Re: Crown-Indigenous Relations and Northern Affairs Canada's (CIRNAC's) Review of the 2023 Annual Report for Meliadine Gold Mine Project, Type A Water Licence No. 2AM-MEL1631.

Technical Review Memorandum

Subject: Crown-Indigenous Relations and Northern Affairs Canada's (CIRNAC's)
Review of the 2023 Annual Report for Meliadine Gold Mine Project, Type
A Water Licence No. 2AM-MEL1631.

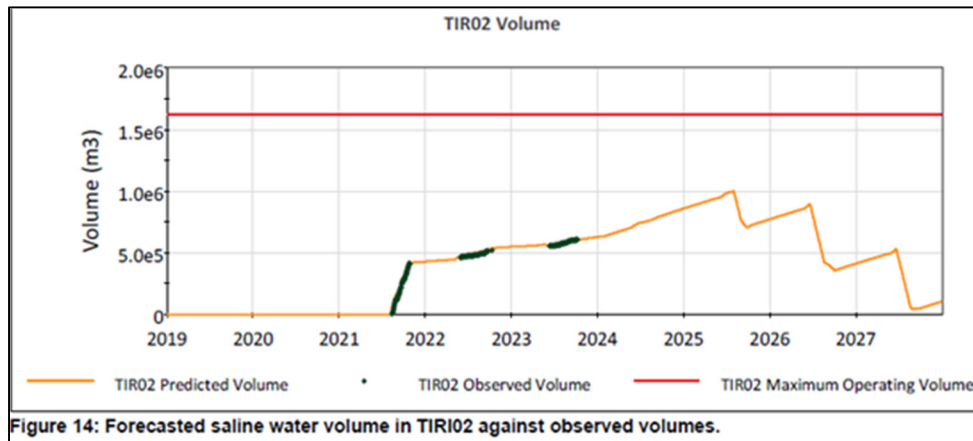
Section 3.2.1.4 Figure 14 shows the results of modelled and observed volumes of saline water in TIRI02, noting that saline water pumped from Tiriganiaq underground will be stored in TIRI02 until 2025, after which the water will be discharged through the waterline to Itivia Harbour. Predicted groundwater inflow rates to the underground mine were updated in 2024 to reflect an updated mine plan scenario and included a limited calibration based on groundwater inflow monitoring over previous years. The updated results are discussed in the Groundwater Management Plan (GWMP).

As seen in Figure 14, the saline water stored in the pit was approximately 500,000 m³ in 2023. This varies significantly from the 373,906 m³ total reported in the annual reports for the years 2018 to 2023. Note that these volumes do not include the reduction of pit volumes for any discharge of saline water that occurred from 2019 to 2021.

Based on this table, additional groundwater inflow to the pit would be 328,500 m³ from 2024 to 2025, for a total of 702,406 m³. This varies substantially from the 1,000,000 shown in Figure 14.

- Explain the difference between the total volume of underground saline water pumped to surface as reported in Section 3.1.3 from 2018 to 2023 to the volumes shown in Figure 14 to 2023, and
- Reconcile the differences in the predicted groundwater inflow rate going forward from 2024.

From the 2023 Annual report (Appendix 4, page 492):

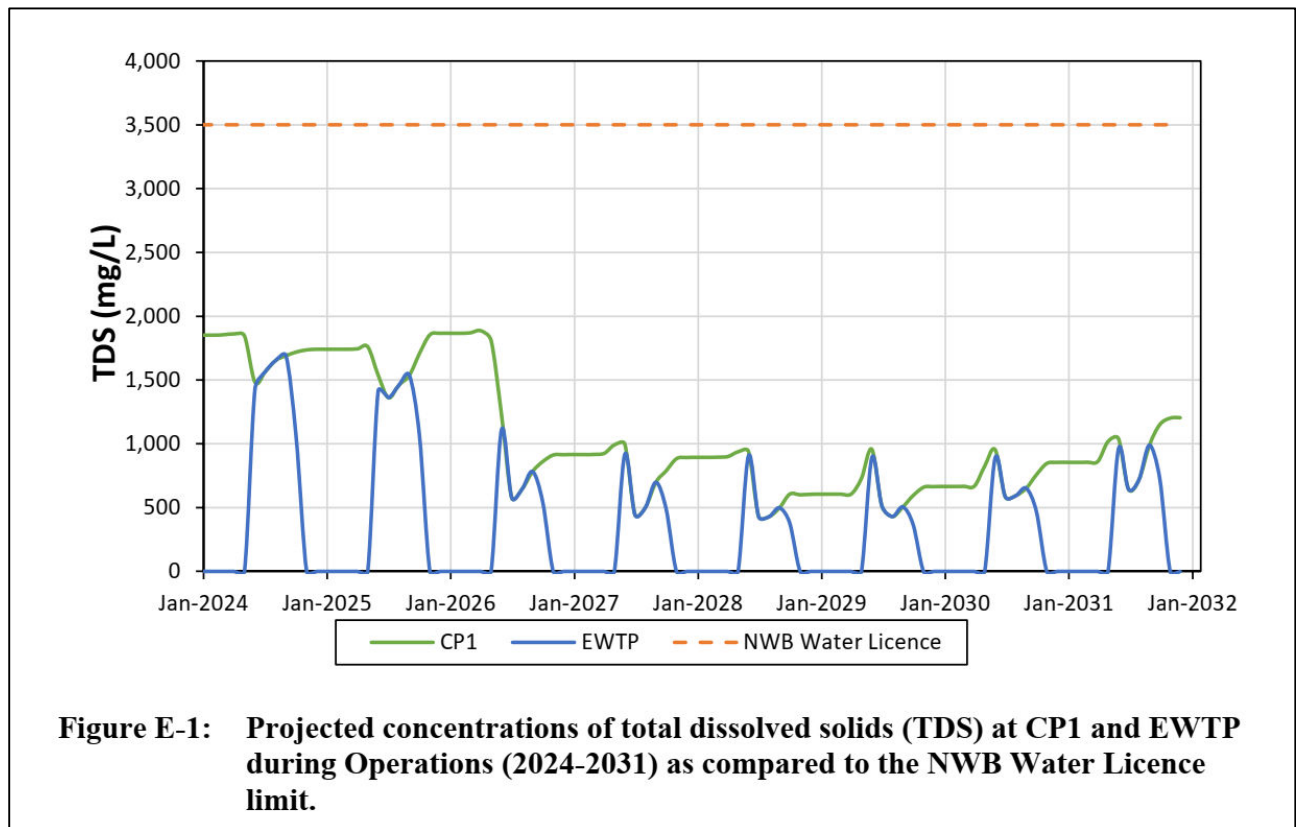
As shown in the figures below, the total dissolved solids (TDS) predicted concentrations in CP1 presented in Appendix 4 of the 2023 Annual Report are much higher than the TDS predictions presented during the Meliadine Amendment process (Lorax Memo, 23 February 2024). It is not clear to CIRNAC why there would be a discrepancy in the CP1 TDS predictions between documents.

- a) The Water Balance and Water Quality Modelling (WBWQM) figures showing concentrations during operations, closure and post-closure,
- b) Clarification on the differences in predicted CP1 TDS concentrations between the 2024 Amendment Application and the 2023 Annual Report from 2024 to 2028.
